14 CFR Part 39

[Docket No. 2003–SW–10–AD]

Airworthiness Directives; Eurocopter France Model AS355E, F, F1, F2, and N Helicopters

ACTION: Notice of proposed rulemaking (NPRM).

Figure 1

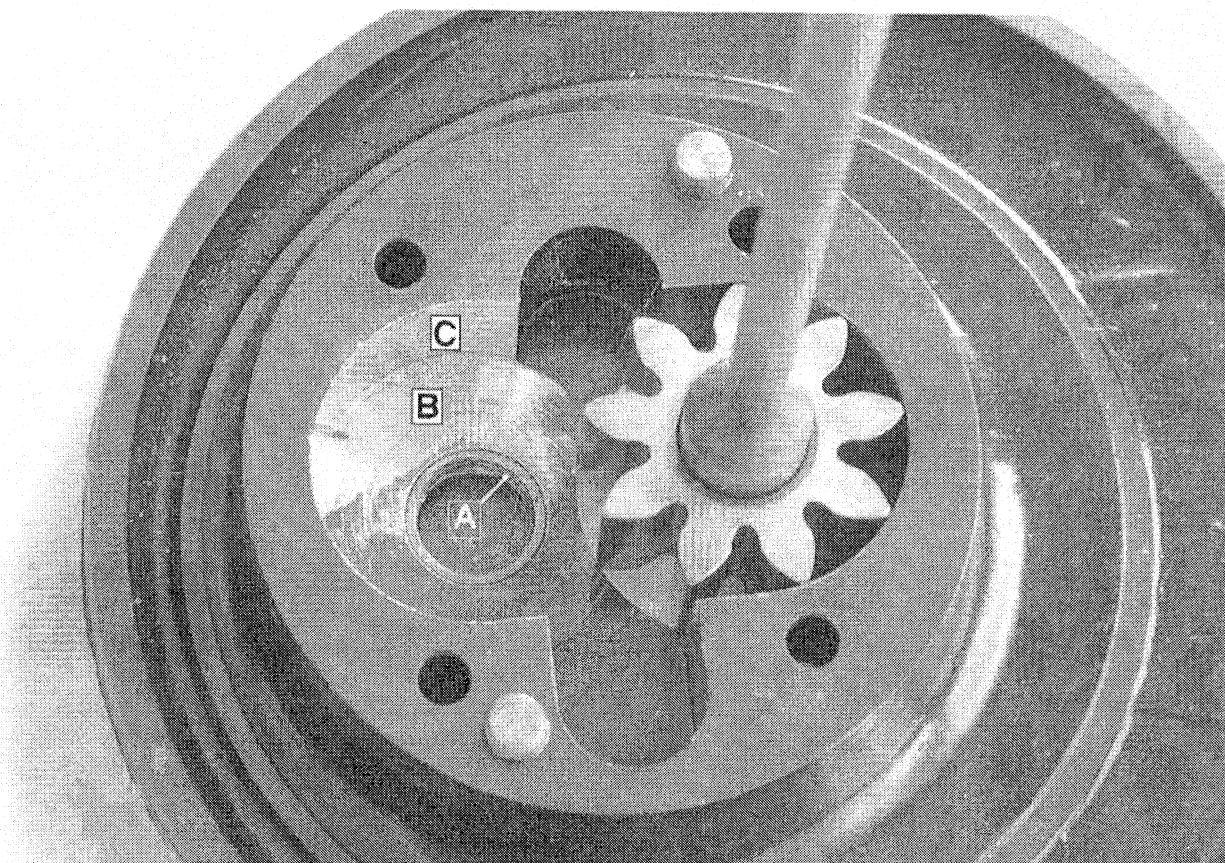
(d) While inspecting the pump, if you find any of the following, replace the MGB and the pump with an airworthy MGB and pump before further flight:

- (1) Crank pin play,
- (2) Out of round bronze bushing (A of Figure 1),
- (3) Offset of the driven gear pinion,
- (4) Metal chips, or
- (5) Wear (C of Figure 1).

Note 2: If wear is present in the B area only as depicted in Figure 1, replacing the MGB and the pump is not required.
